Supplement No. 1

**HAZARDS SUMMARY REPORT
PREPACKAGED
NUCLEAR POWER PLANT
FOR AN ICE CAP LOCATION
(PM-2A)**

APAE No. 49 Supplement No. 1

Issued: April 15, 1960

Fig. III-2A - Vapor Container

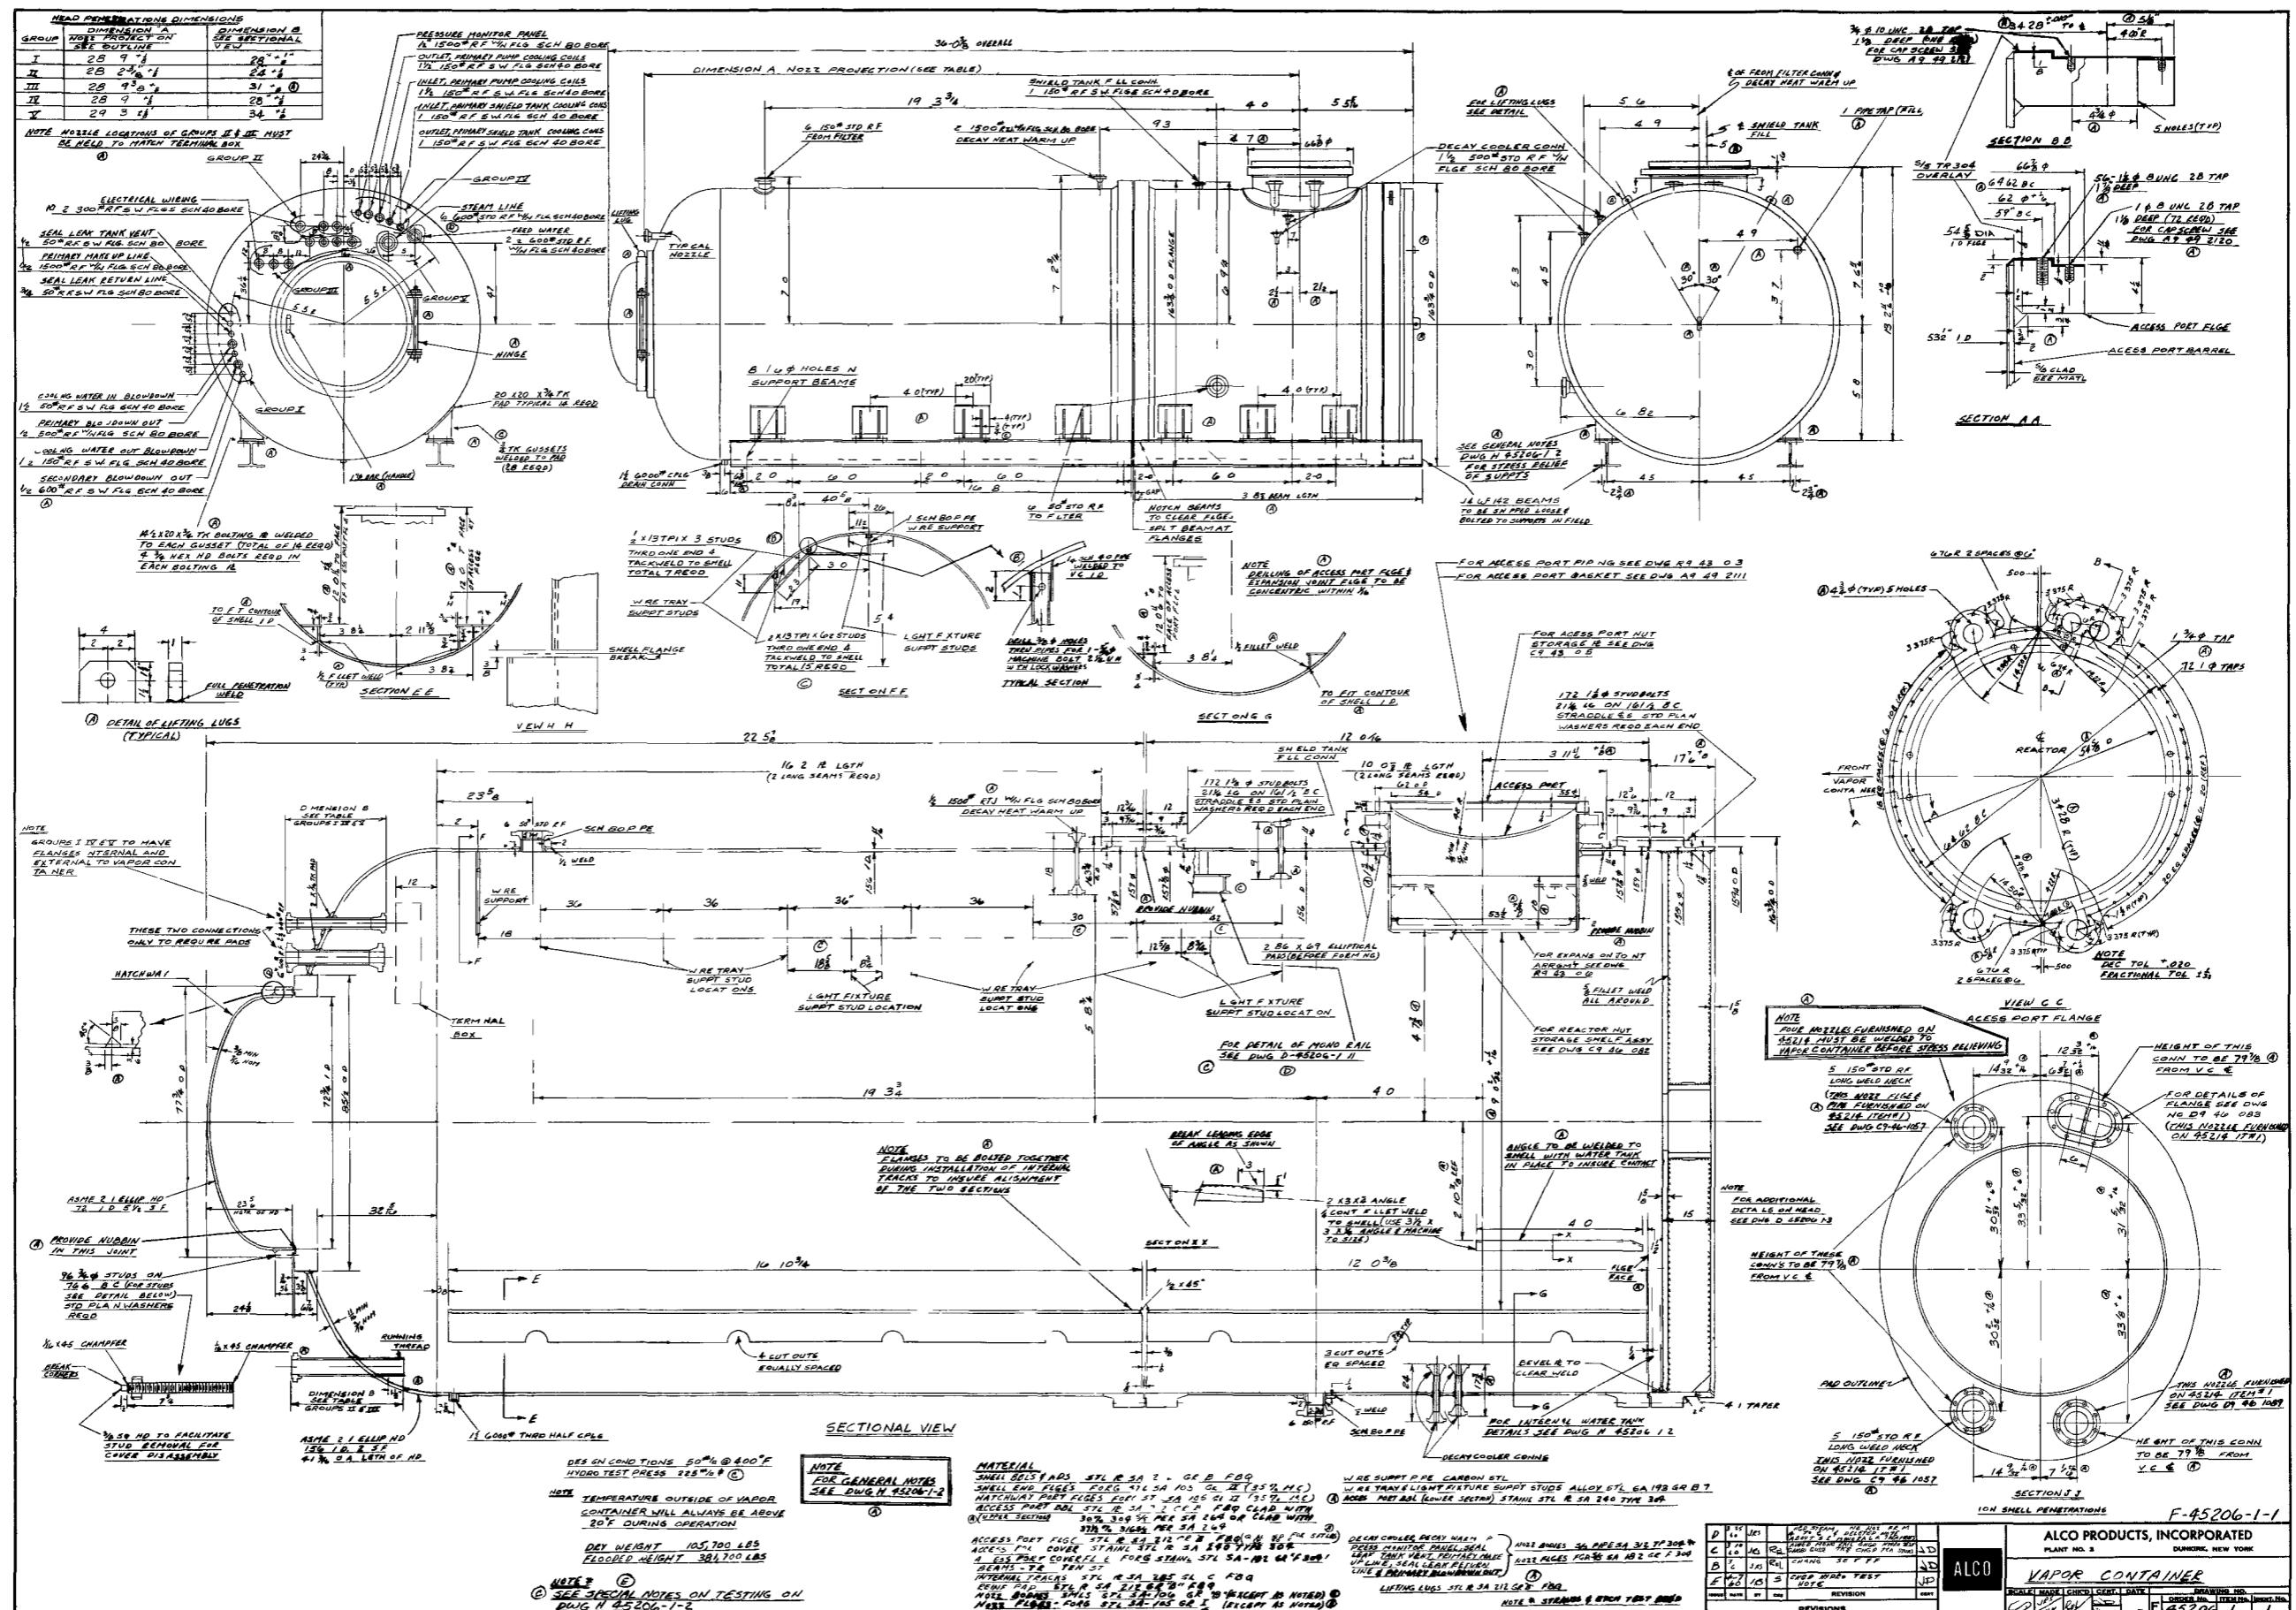
Despite the revision in the fabrication and assembly of the vapor container (two flanges versus original field welding), information contained in Chapter III, section 1.5 and in Chapter IV still pertains to the design and no elaboration is needed on the revised flanged vapor container.

<u>Old Figure No.</u>	<u>New Figure No.</u>	<u>Title</u>
III-2	III-2A	Vapor Container
None	III-3	Vapor Container Head Assembly
None	III-4	Internal Water Tank
None	IV-3	Shielding between Primary Shield Tank and Vapor Container Head
V-1	V-1A	Plant Layout
V-2	V-2A	Spent Fuel Handling System
VI-5	VI-5	Decay Heat Cooling
